[OBJECTION LETTER – PEX2024/0002]

Re: PEX2024/0002

As you are aware this Planning Proposal application (PEX2024/0002) seeks a site-specific amendment to Warringah Local Environmental Plan 2011 (WLEP 2011) to increase the maximum height of buildings permitted on the site from 12 and 13 metres to 32 metres at the corner of Dee Why Parade and Pittwater Road, and 23 metres across the remainder of the site. It is to expressly develop the site for seniors housing, which is already a permissible use on the land, as it is zoned R3 Medium Density Residential under WLEP2011. The Planning Proposal also seeks to implement site-specific development provisions to guide a future seniors housing development on the site, for inclusion as an amendment to Warringah Development Control Plan (WDCP 2011).

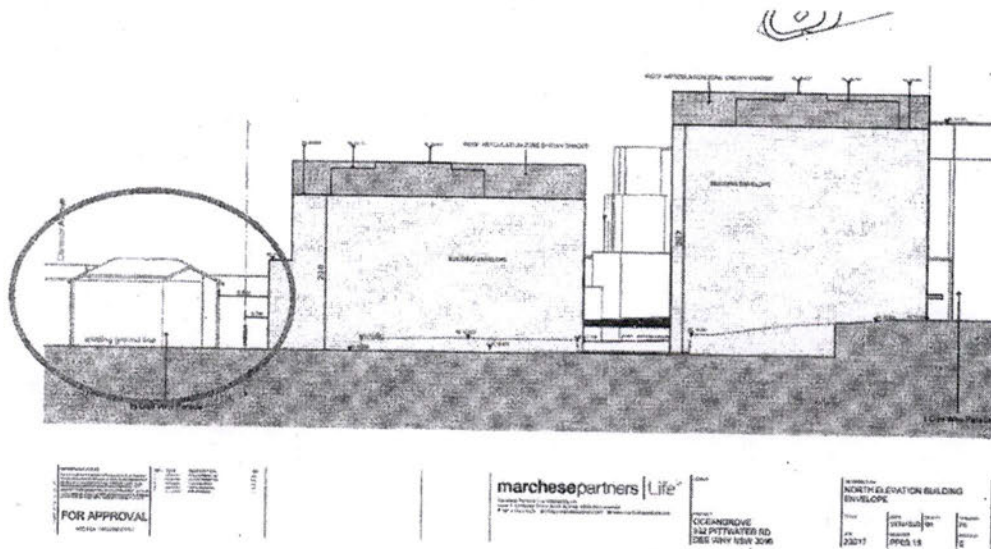
Image above - The information provided with this Planning Proposal identifies “possible future built form” however shows the existing building on the site. No attempt has been made to demonstrate that the potentially isolated site is able to be re developed. The site should be included in the proposed building height “uplift” to ensure uniform development controls apply.

Figure 13 Development Concept building envelope and site context

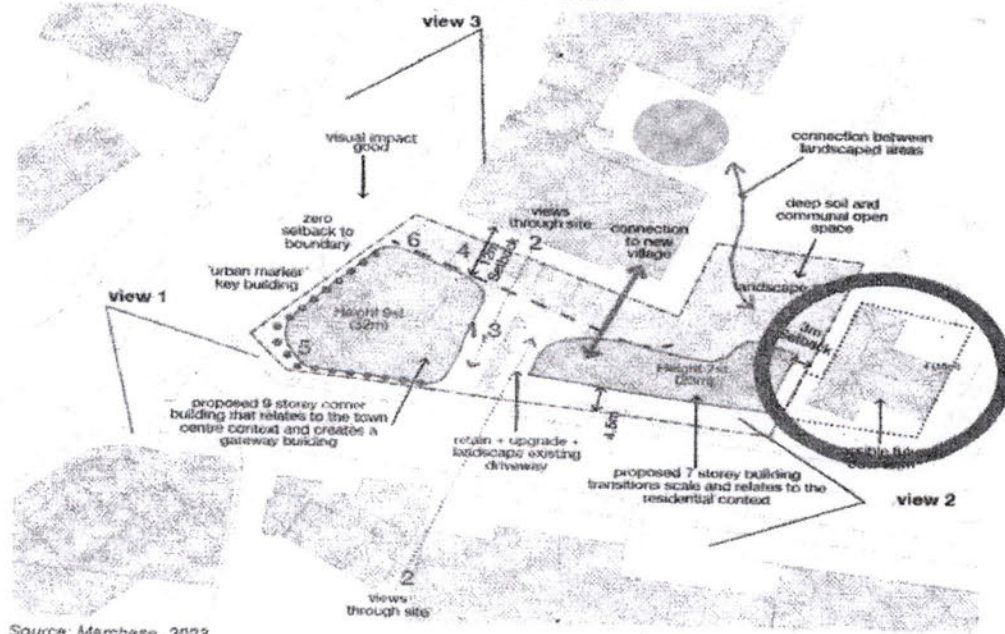
Image above - From the report appears to show “existing” development rather than “possible future development” there does not appear to be any substantive demonstration that the site can be developed independently.
